TVA-BFN-TS-414 Supplement 2

**BROWNS FERRY NUCLEAR PLANT (BFN) - REDUCTION IN REQUESTED
EFFECTIVE FULL POWER YEARS (EFPY) FOR TECHNICAL
SPECIFICATIONS (TS) CHANGE NO. 414 - PRESSURE - TEMPERATURE
(P-T) CURVE UPDATE**

PROPOSED TECHNICAL SPECIFICATION (TS) CHANGE TS-414 SUPPLEMENT
2

Figure 3.4.9-1
Pressure/Temperature Limits

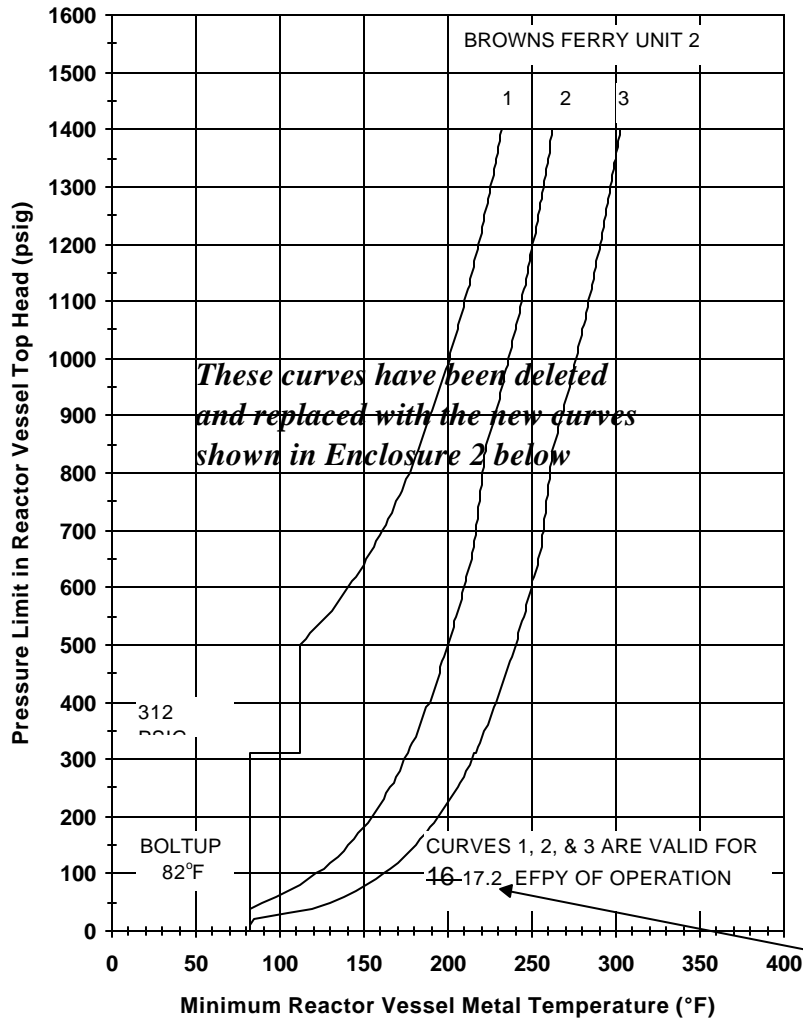
Added "ASME" for additional
clarity in this note.

The period of valid use of these curves has been changed from 16 to 17.2 EFPY.

**Figure 3.4.9-1
Pressure/Temperature Limits**

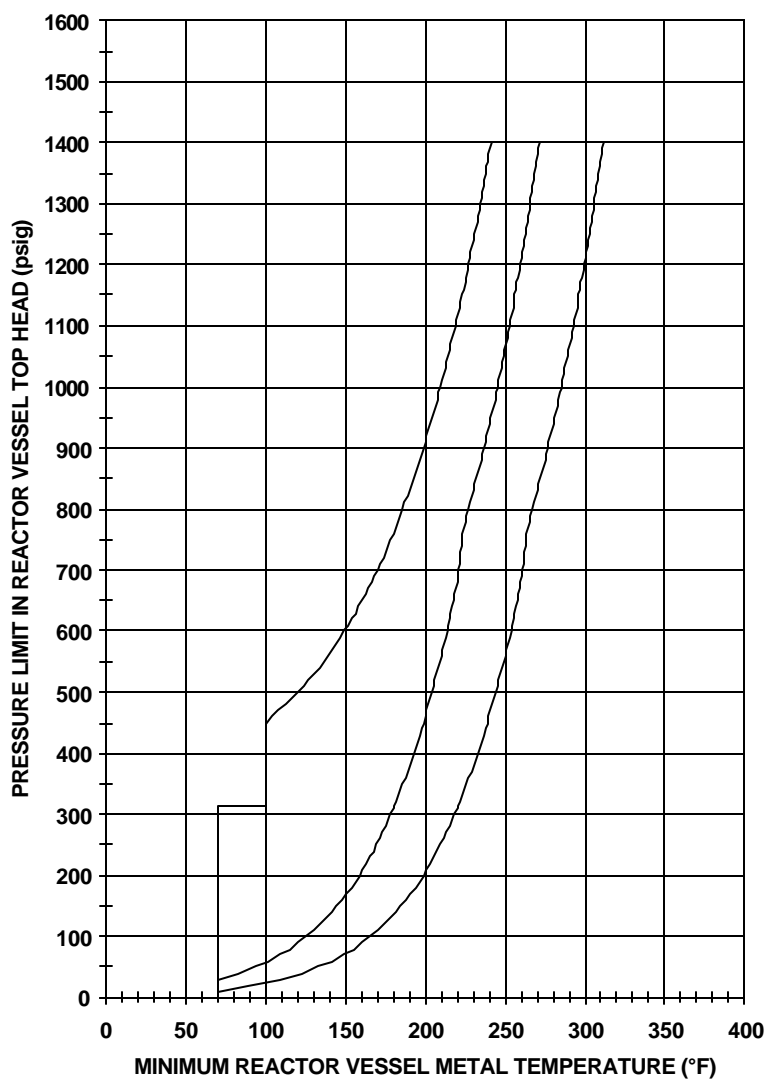
Added "ASME" for additional clarity in this note.

These curves include sufficient margin to provide protection against feedwater nozzle degradation. The curves allow for shifts in RT_{NDT} of the Reactor vessel beltline materials, in accordance with Reg. Guide 1.99, Rev. 2, to compensate for radiation embrittlement for 20 13.1 EFPY.

These curves have been deleted and replaced with the new curves shown in Enclosure 2 below

CURVES 1, 2 & 3 ARE VALID
FOR 20 13.1 EFPY OF
OPERATION

The period of valid use of these curves has been changed from 20 to 13.1 EFPY.

**Figure 3.4.9-1
Pressure/Temperature Limits**

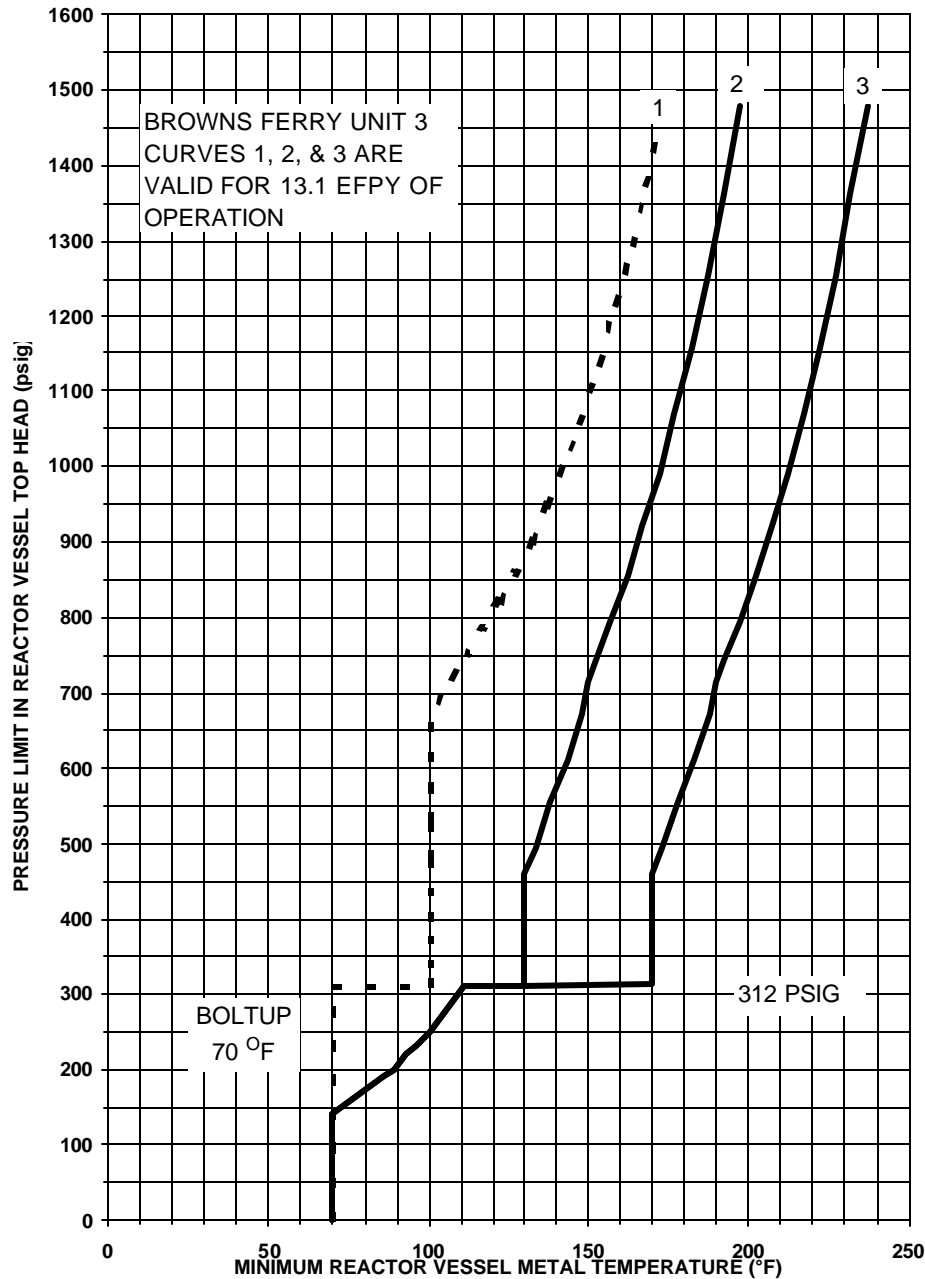
These curves include sufficient margin to provide protection against feedwater nozzle degradation. The curves allow for shifts in RT_{NDT} of the Reactor vessel beltline materials, in accordance with Reg. Guide 1.99, Rev. 2, to compensate for radiation embrittlement for 17.2 EFPY.
